Imray Correction Notice

ICC39-2

Chart C39 WGS 84

Edition 2017

33 Étel E

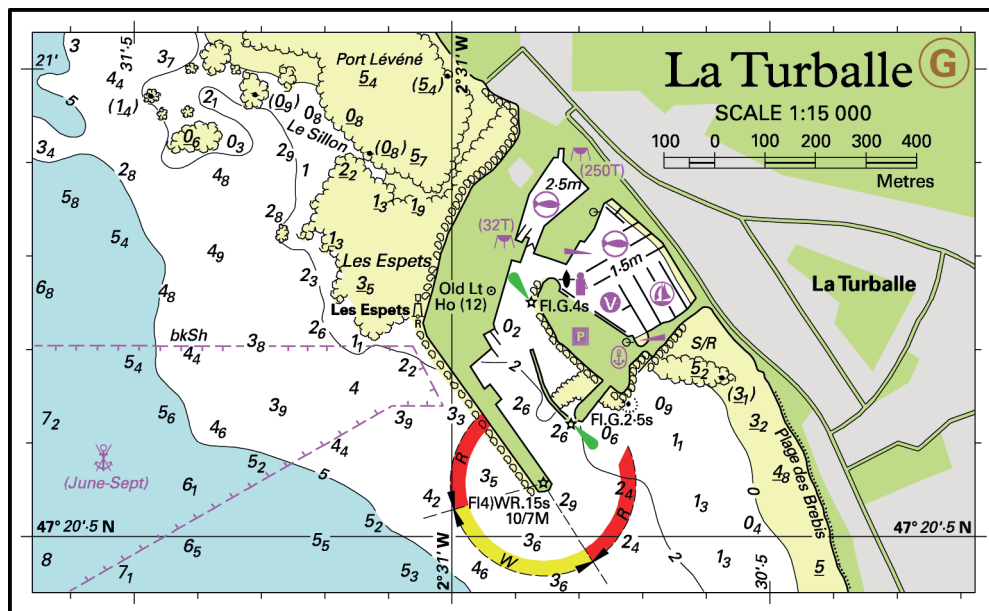
Insert circular limit of seaplane operating area radius 1000m centred on 47°40'·00N 3°18'·00W (ILNW 506/24)
